Norwich to Tilbury

Document: 7.4 Outline Landscape and Ecological Management Plan
Appendix D - Outline Landscape Proposals - Tracked Changes Version

Final Issue C

Project			NORWICH TO TILBURY		
Client					
NATIONAL GRID					
LUC Job Nr		Scale @A3		Status	
12055		1:5000		S1	
Drawing Title					
Norwich Substation					
Landscape Proposals					
Drawing Nr					Rev
12055-LUC-XX-XX-DR-L-0001					C

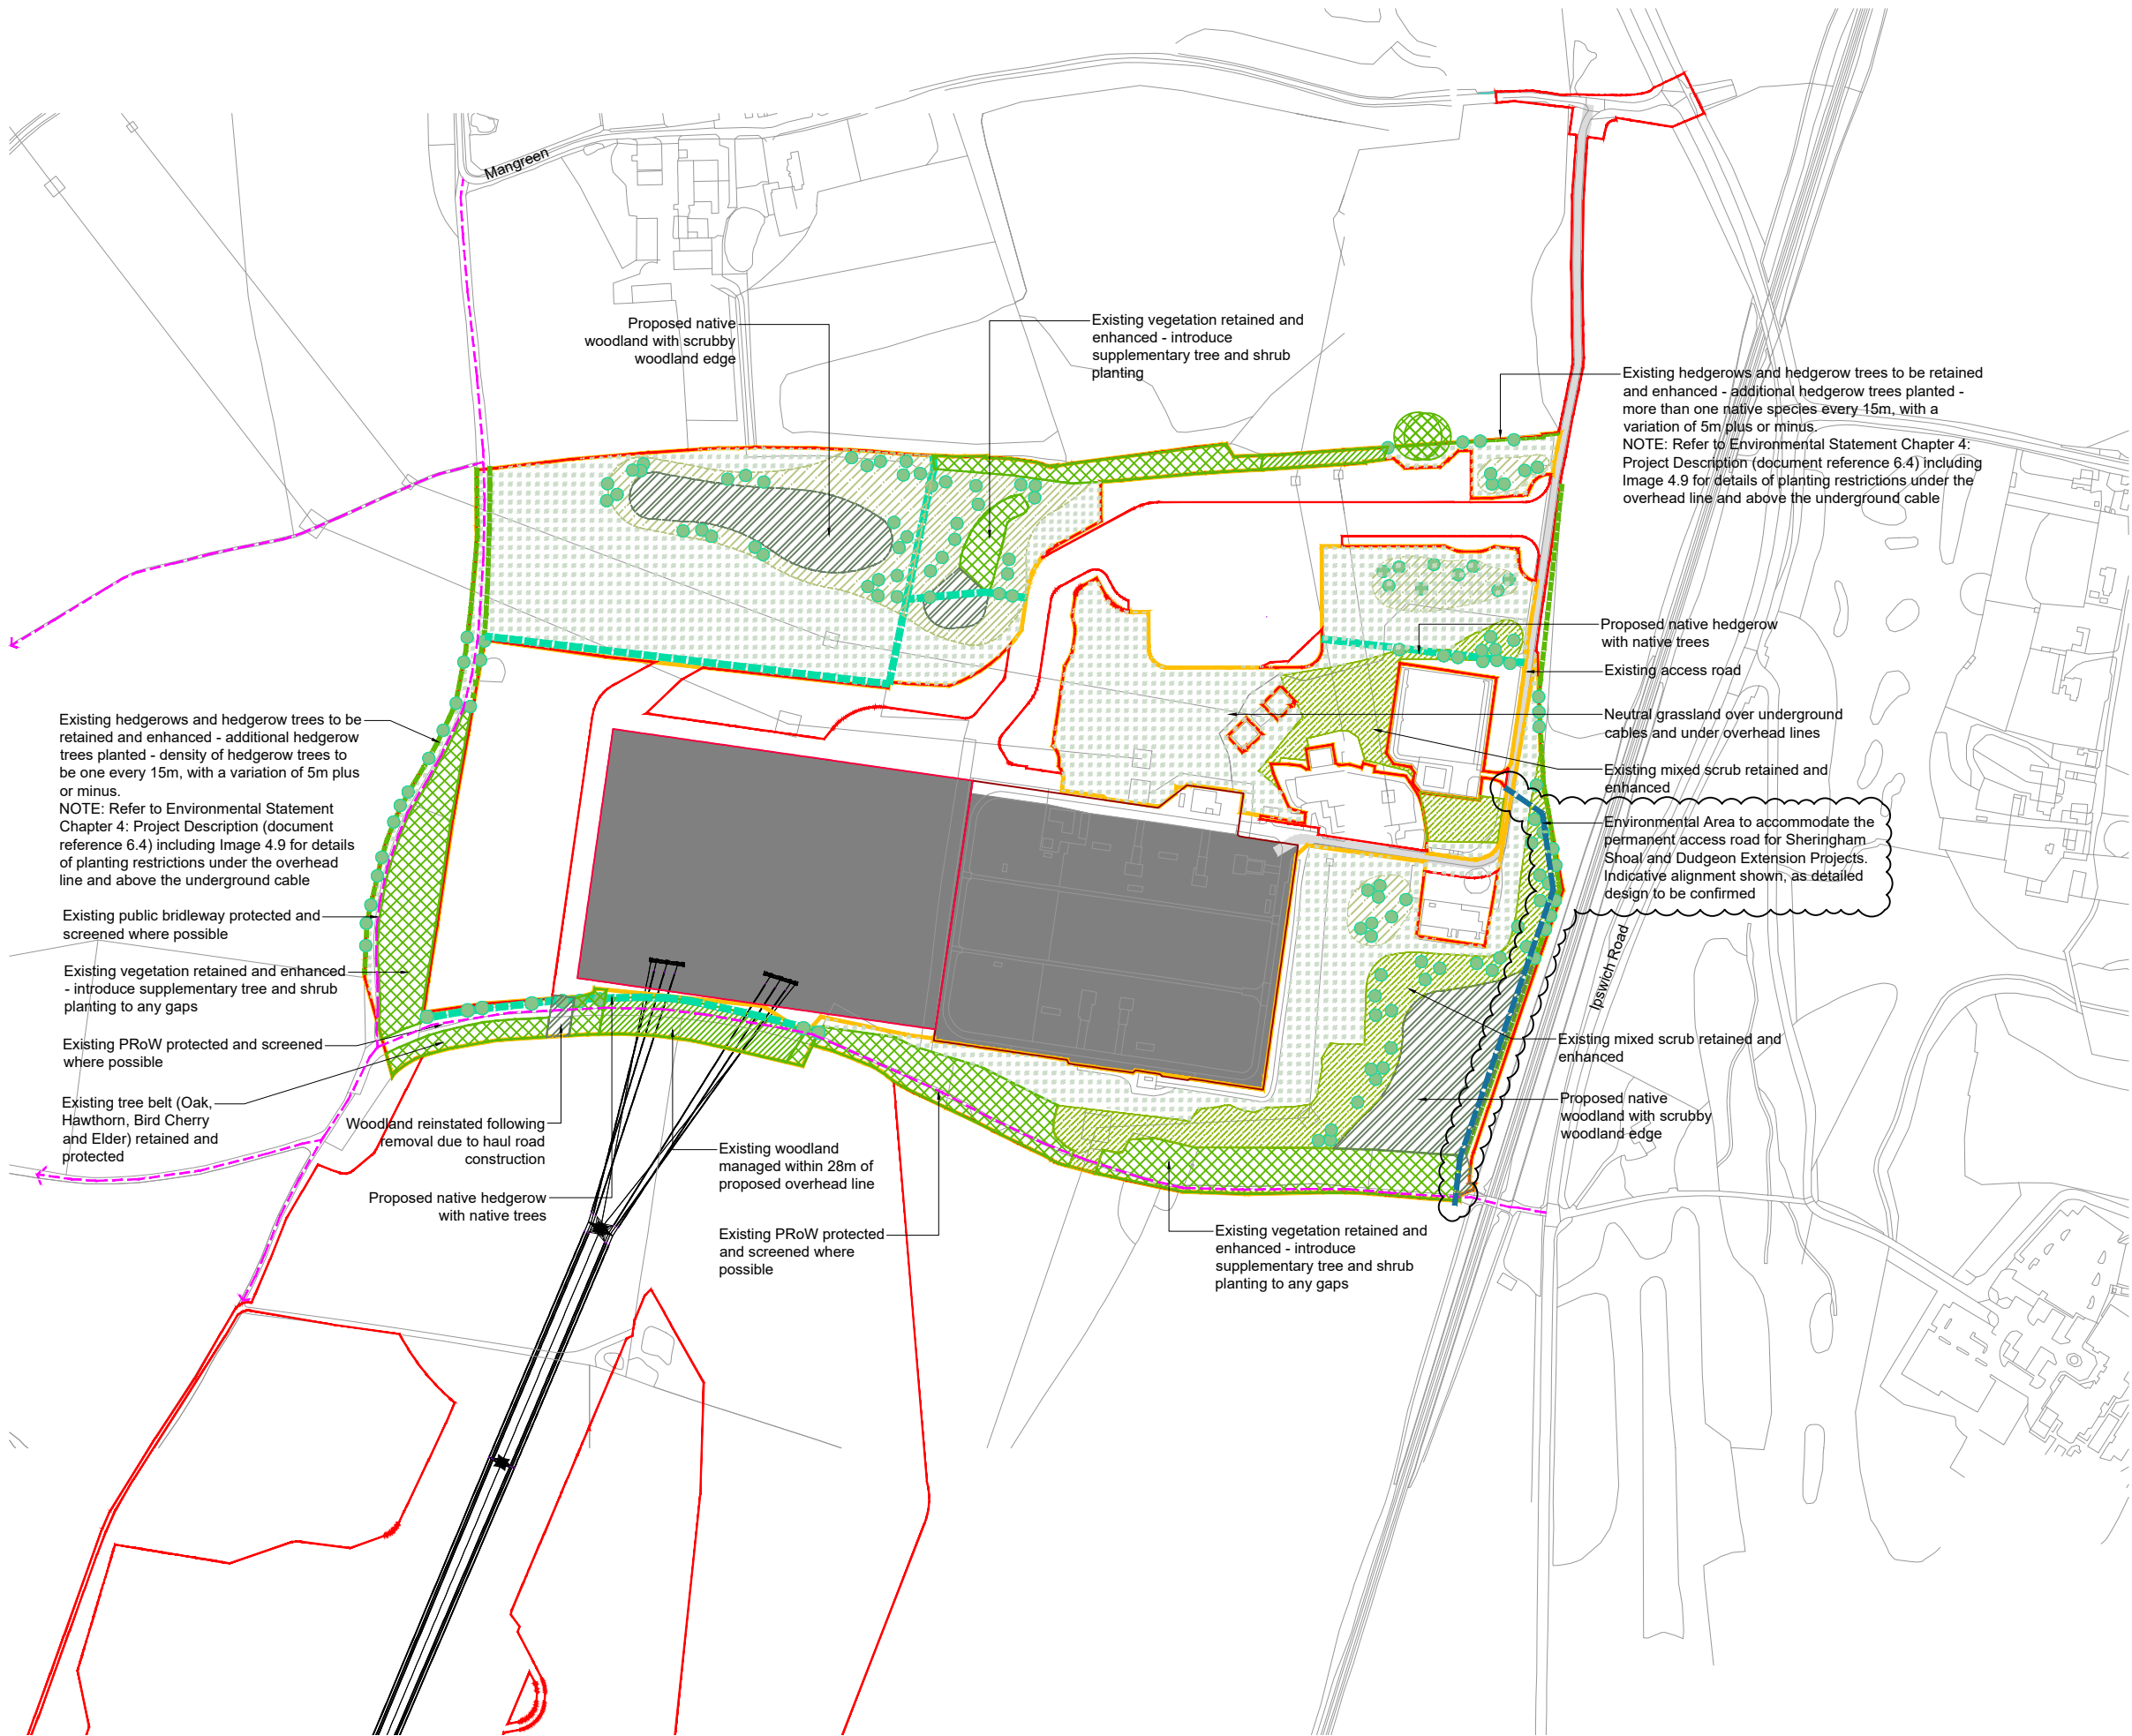
C	July 2026	Updated following client comment	AR	LC	RG
B	June 2026	Indicative road added	LT	LC	RG
A	Aug 2025	FOR DCO APPLICATION	LT	LC	RG
